**CITY OF WEST DES MOINES
PLAN AND ZONING COMMISSION COMMUNICATION**

Item: Wolfe Clinic Surgery Center, 6100 Westown Parkway – Approval of a Phased Major Modification to a Site Plan to construct a surgery center building with site modifications – Wolfe Eye Clinic – MaM-003821-2018

Requested Action: Approval of a Phased Major Modification to a Site Plan

SITE LAYOUT PLAN

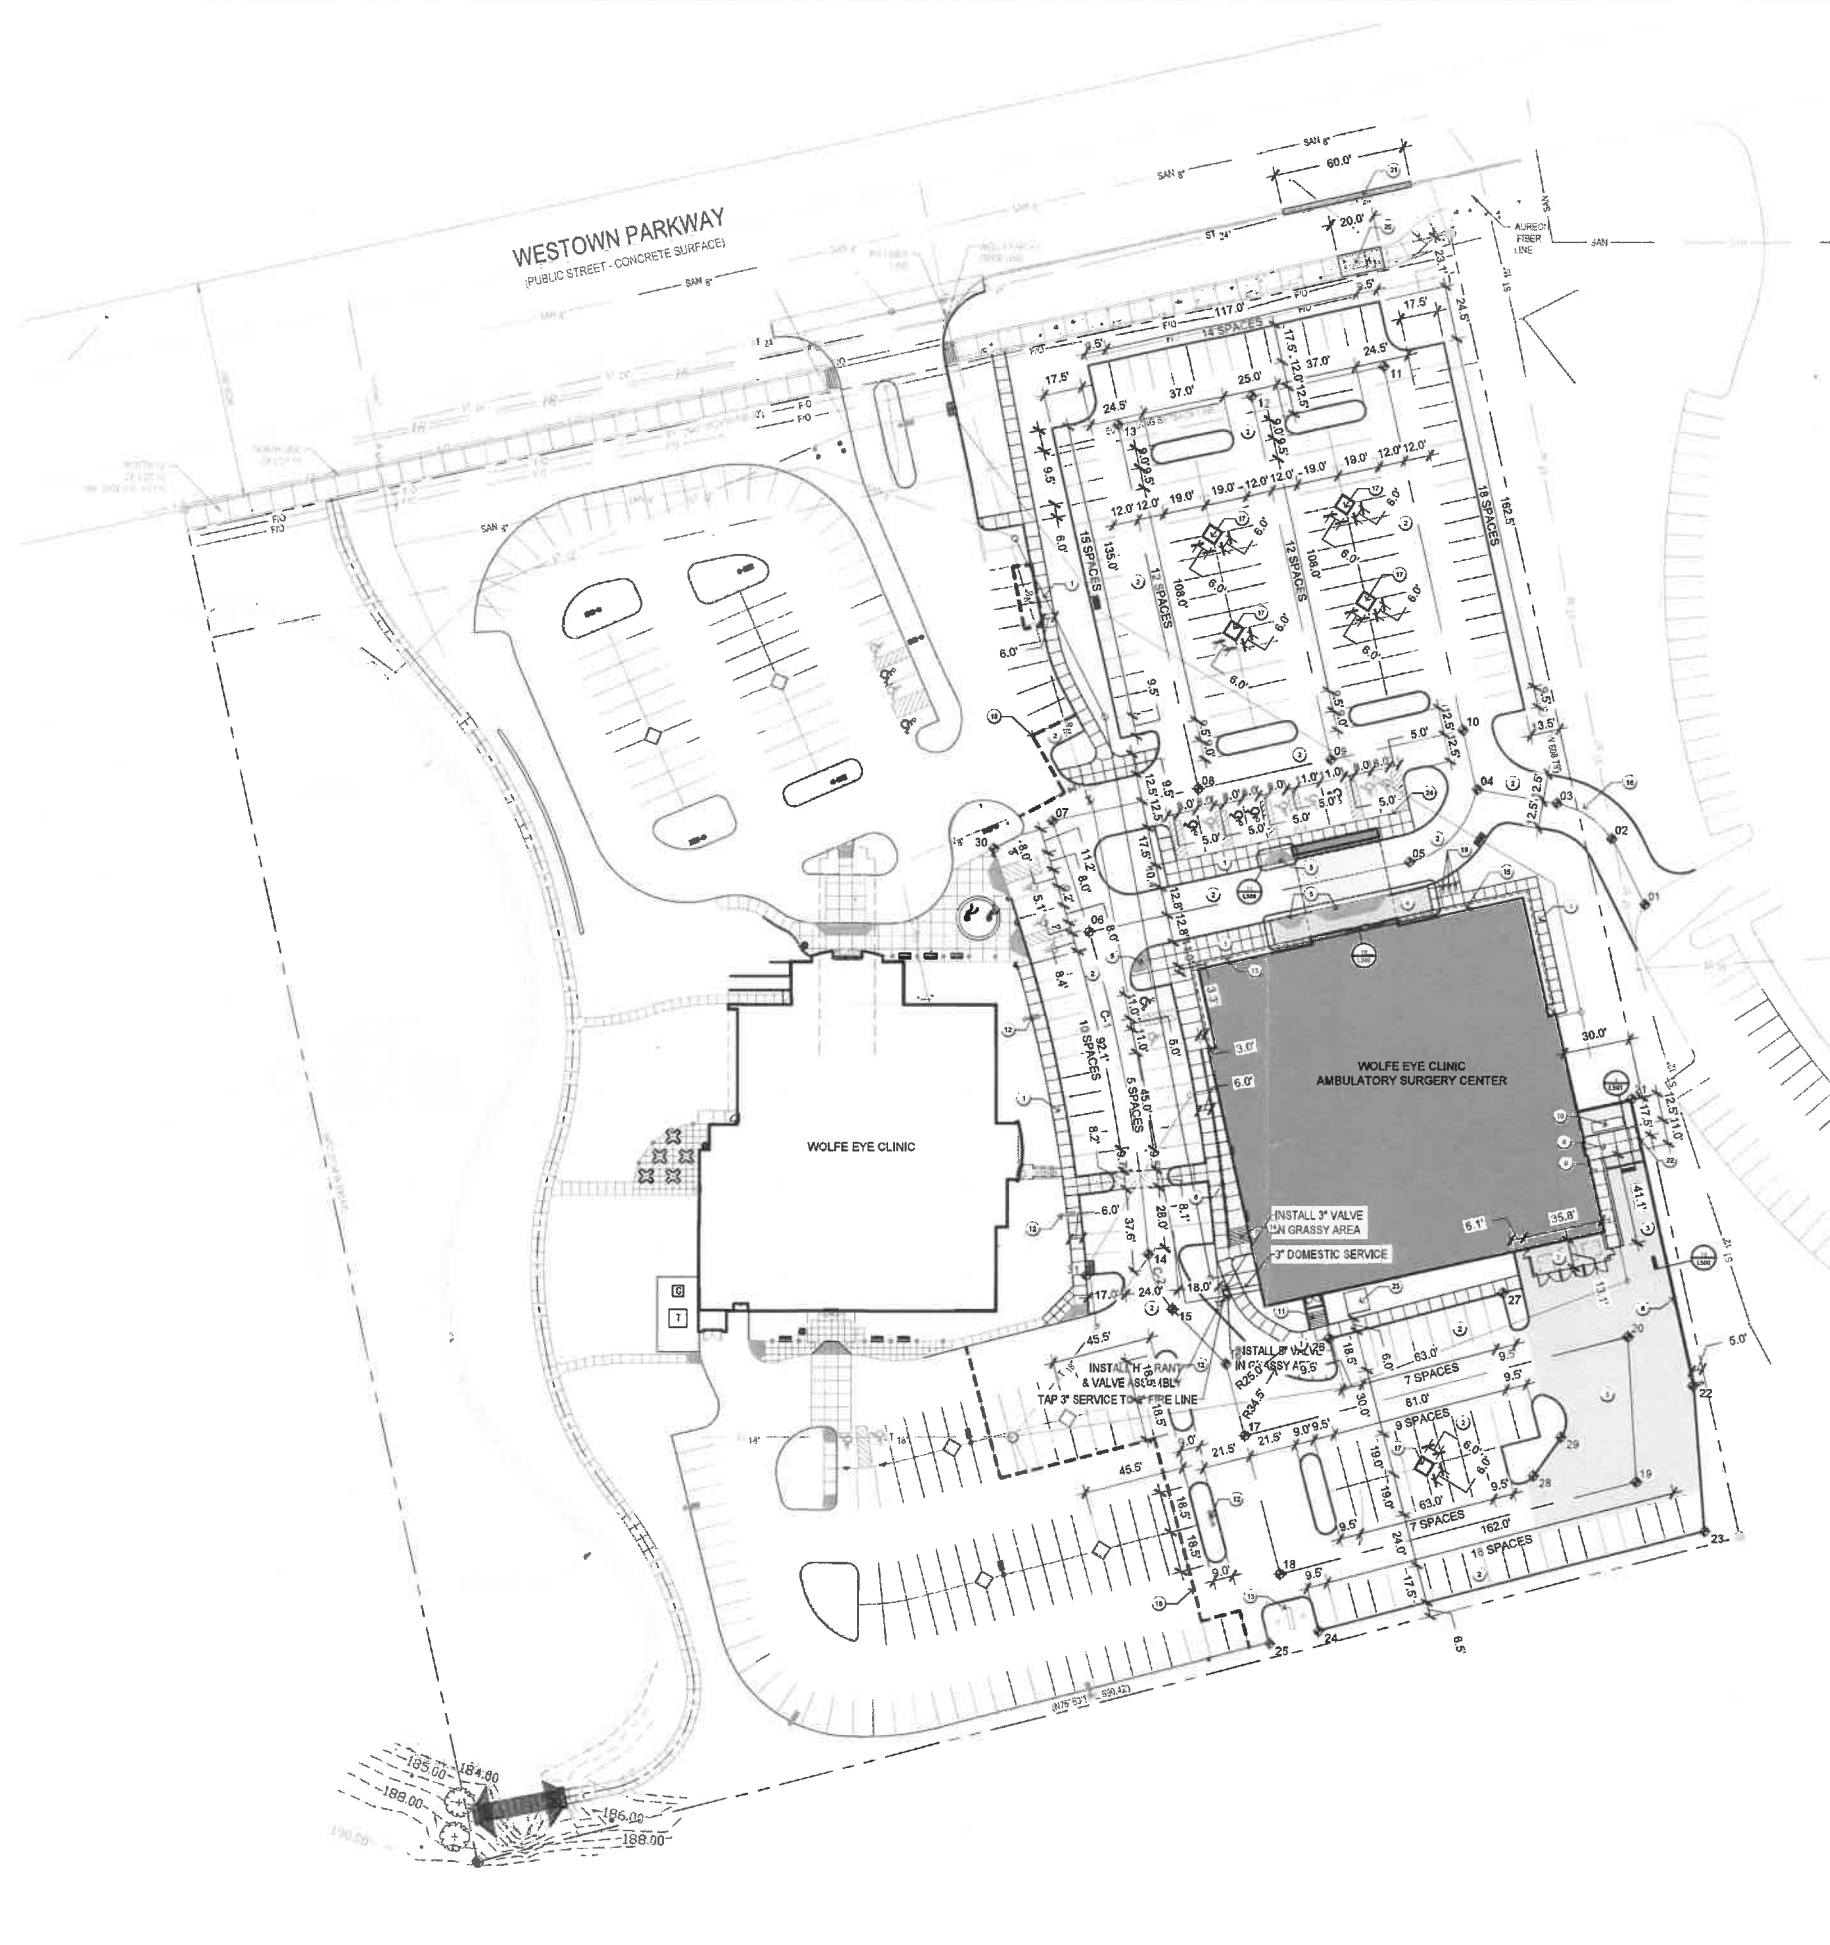
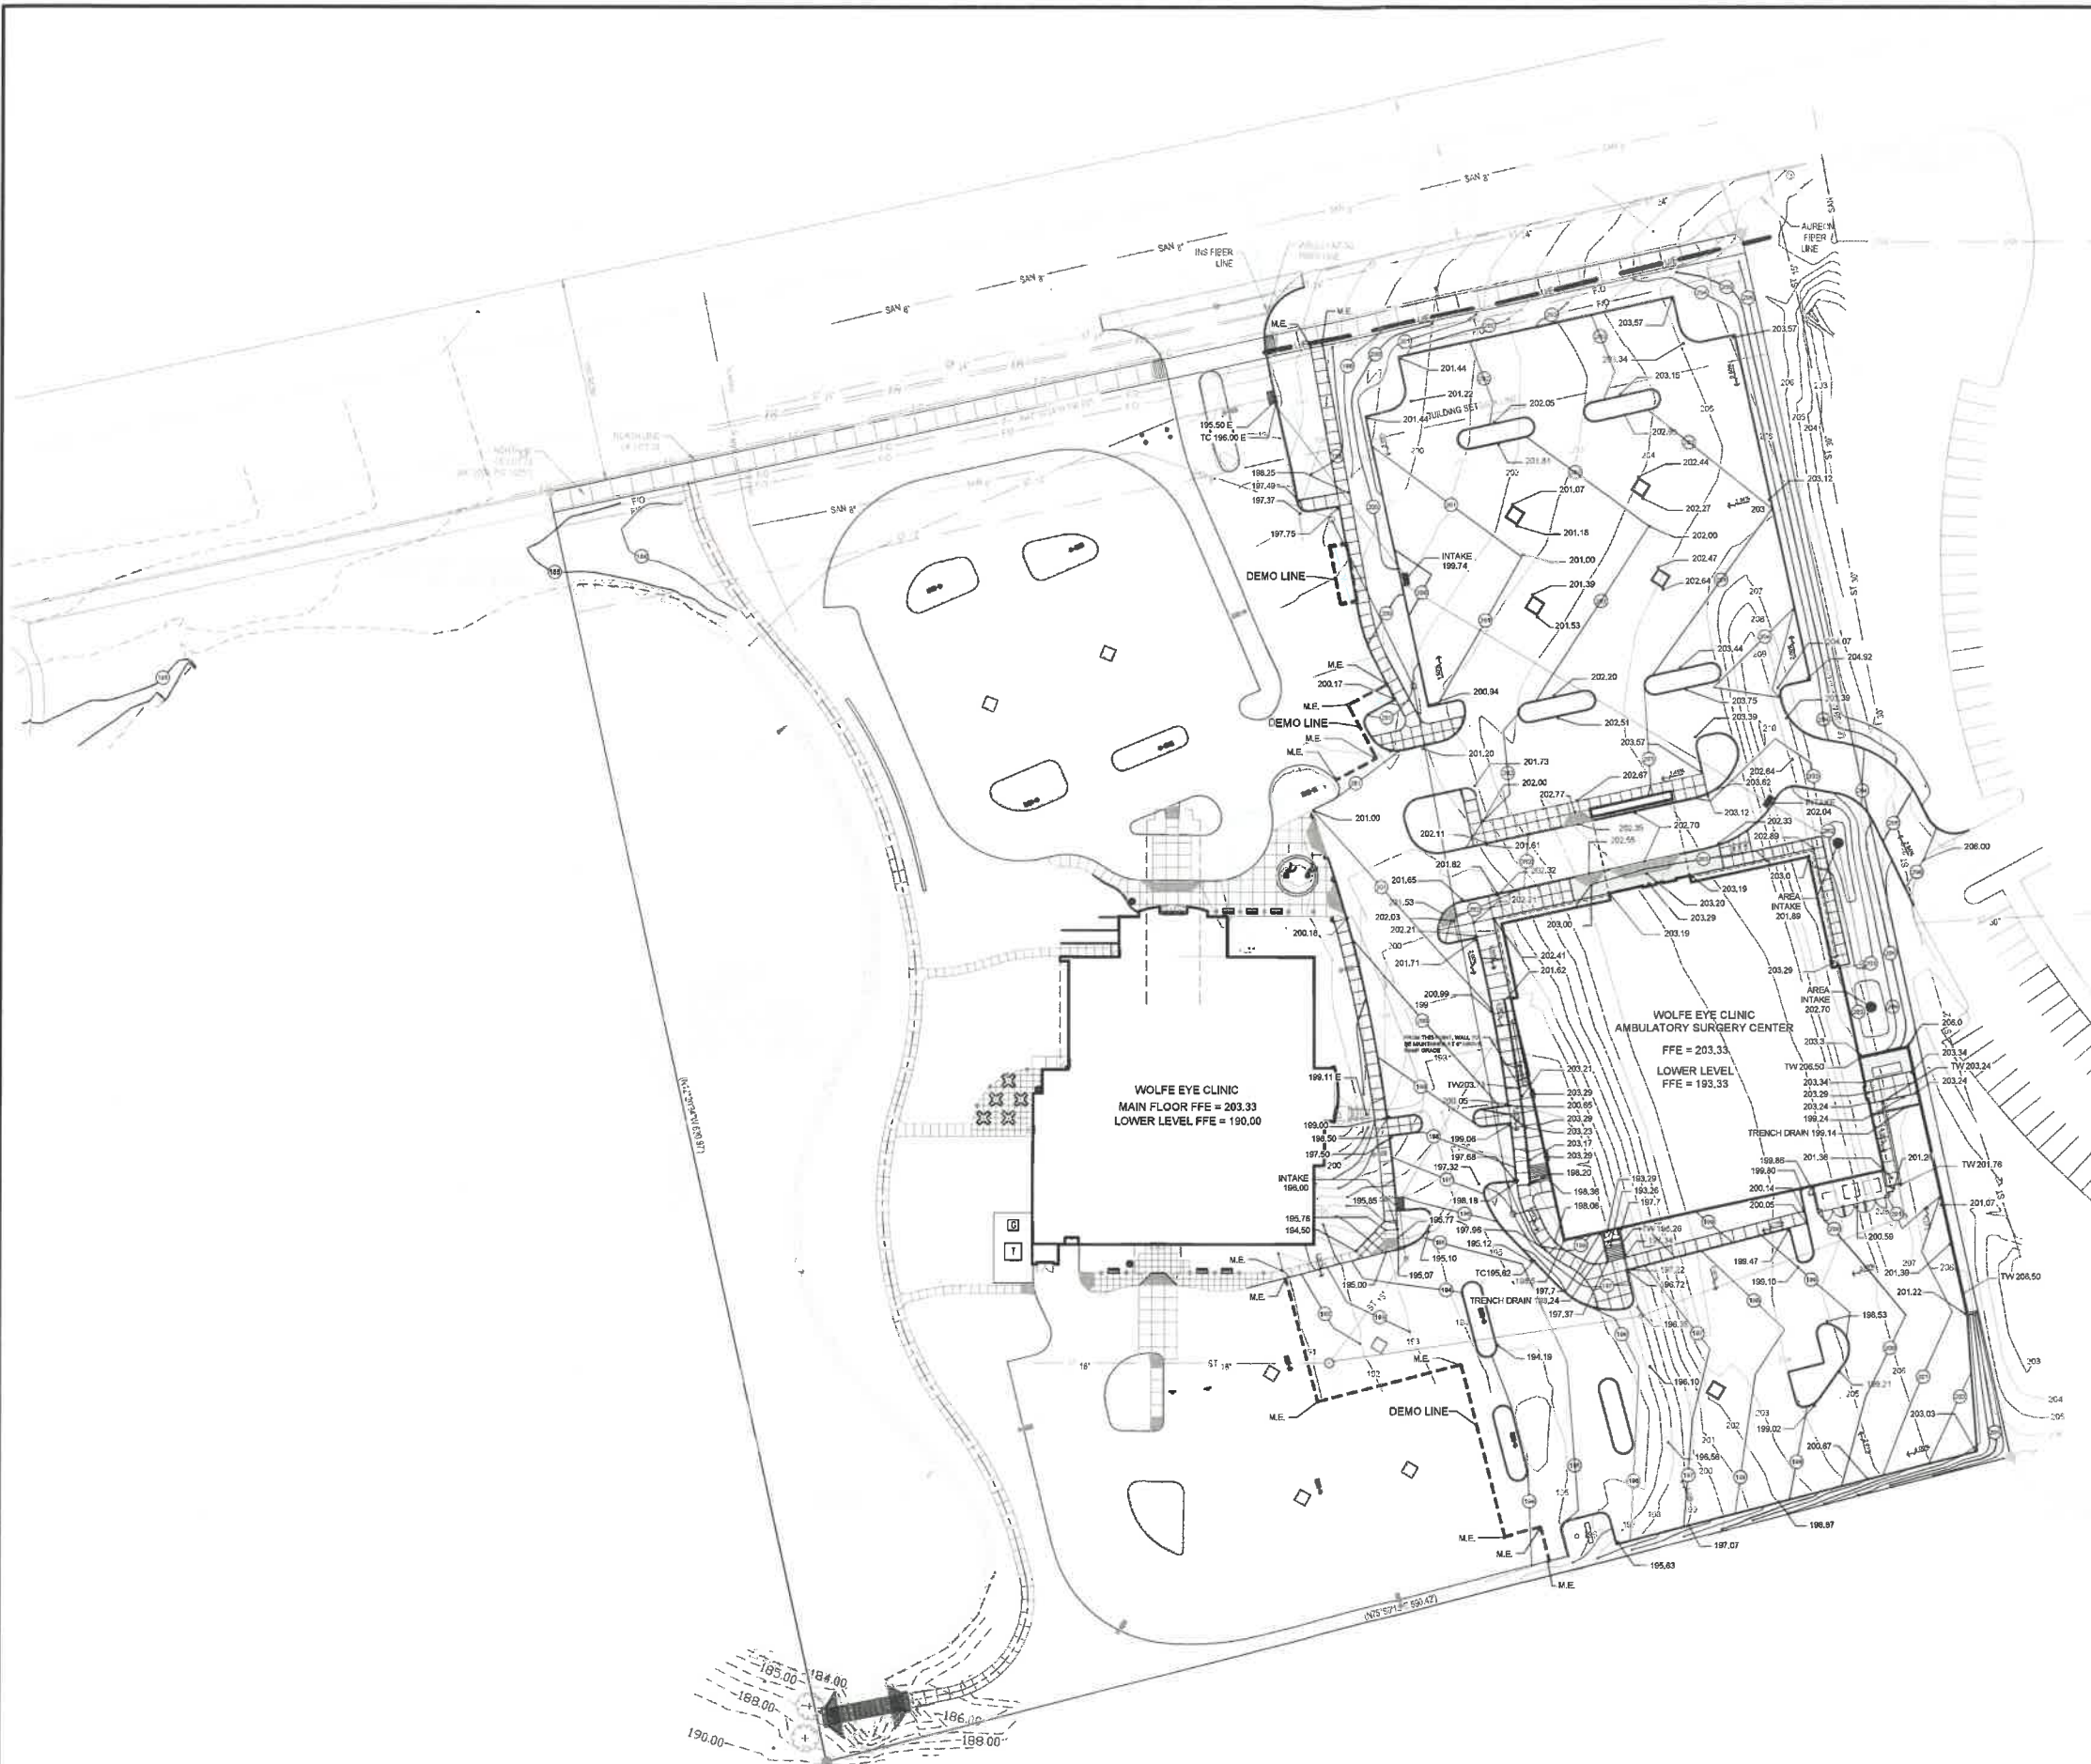
- **Temporary Construction Access:** The applicant has proposed a temporary construction access on Westown Parkway as part of the proposed site work. The applicant has indicated this temporary access is necessary for a number of reasons including: difficulty of large construction vehicles turning at the existing divided entrance, construction traffic conflicts with normal site traffic, and need for staged construction of proposed parking areas.

Westown Parkway is a minor arterial street. City Code Title 9, Chapter 15, Part 6.C.2 requires a minimum access spacing of 300 feet on arterial streets. The proposed temporary access is shown approximately 220 feet from the existing Wolfe Clinic access and 200 feet from the next access to the east. An access, permanent or temporary, spaced this closely to other driveways will introduce additional conflict points without sufficient distance to identify and react to vehicles entering and exiting at this location. The issue is exacerbated by large, slow-moving construction vehicles anticipated to be using the temporary access. Due to these safety concerns Staff recommends removing the temporary access from the major modification.

A condition of approval is recommended that the City Council not allow an additional permanent or temporary access on Westown Parkway.

1. The City Council would not allow additional permanent or temporary access onto Westown Parkway.
2. The applicant acknowledging and agreeing that this approval is for underground utility, grading, footing and foundation work only.
3. The applicant agreeing that any grading utility work and footing and foundation work done prior to approval of the full site plan is at their own risk, and that final building and site design will need to comply with any changes that are deemed necessary as part of that approval.

13 L500 SECTION: RETAINING WALL @ EAST PROPERTY LINE N.T.S.

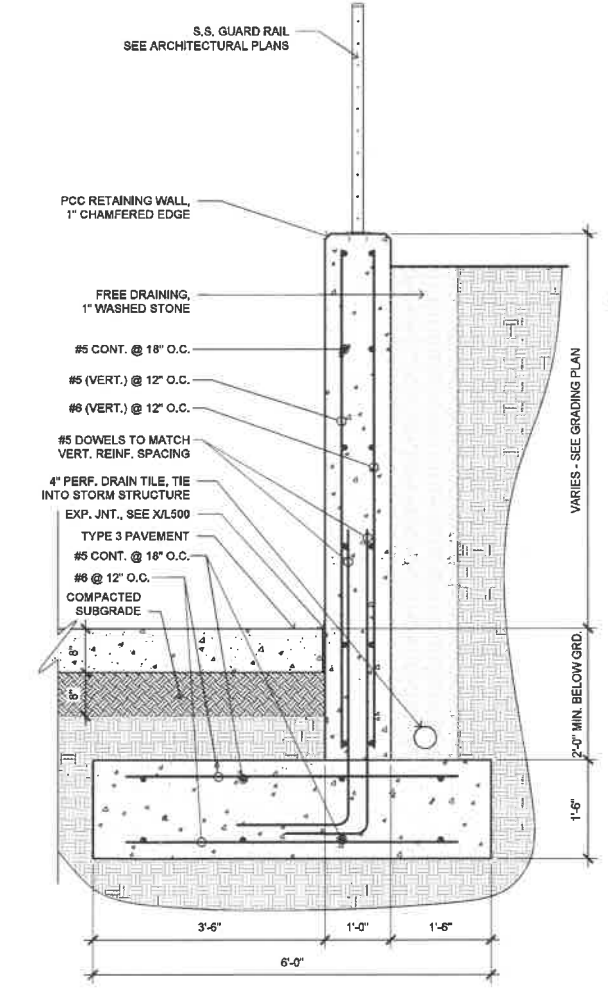
- **Retaining Wall:** The applicant is planning to install a retaining wall in the southeast corner of the site, adjacent to the loading dock. City Code states that no single wall face shall be greater than six feet (6') in height without terraces to break up the wall expanse. The proposed retaining wall does have portions over 6 feet in height at the loading dock area, however the area will have semi-trailers backing in on a regular basis and in an area with limited visibility. A condition of approval will be recommended at the final site plan that the City Council grant a waiver from this requirement.

4. The applicant agreeing that any work done on the installation of the retaining wall on the southeast corner of the lot is at their own risk, and that the City Council must approve the waiving of the terracing as part of the final site plan approval.
5. The applicant continuing to work with staff on outstanding building and site design elements.
